GOVERNMENT OF THE DISTRICT OF COLUMBIA
DEPARTMENT OF TRANSPORTATION

MEMORANDUM

SUBJECT: BZA Case No. 18785 - 1326 Florida Avenue, NE

Figure 1 On-Street Block Face Map (Grove/Slade)

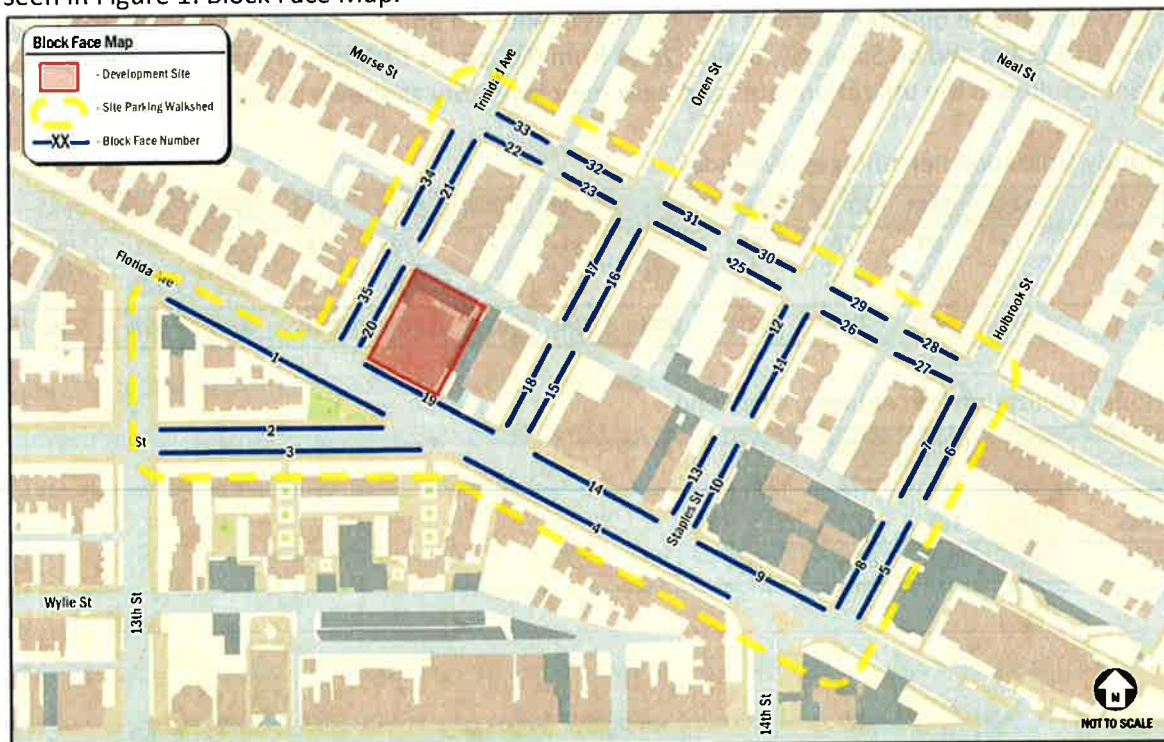
The Applicant's analysis of weekday on-street parking included the following blocks in the study area as seen in Figure 1: Block Face Map.

Figure 2 Summary of Parking Type (Source: Gorove/Slade)

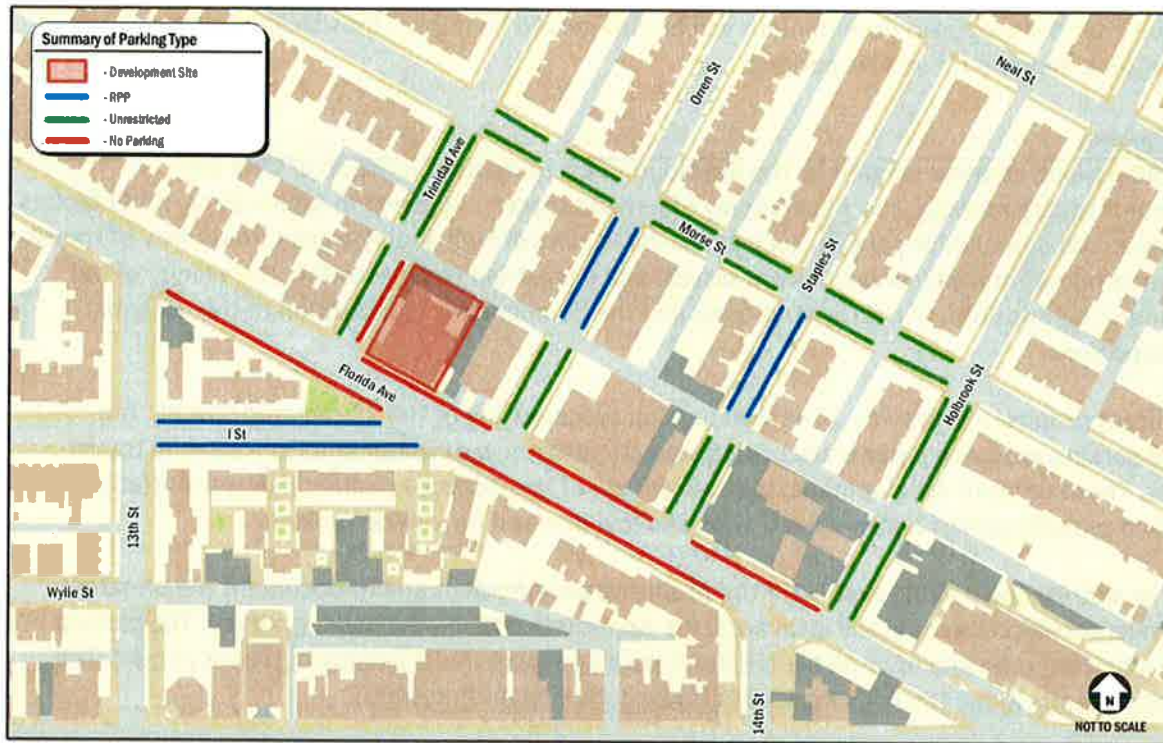
Based on the Applicant's report, there are a total of 127 parking spaces in the study area during the weekday period, of which 47 are subject to Residential Permit Parking (RPP) restrictions and the remaining 80 are unrestricted spaces as seen in Figure 2.

The weekday and weekend peak hours feature very high usage of RPP parking spaces, but availability remains among the unrestricted spaces. Approximately 34 and 14 unrestricted parking spaces are available during the weekday and weekend periods, respectively. Accordingly, the level of on-street parking is likely sufficient to accommodate potential spillover parking from the site.
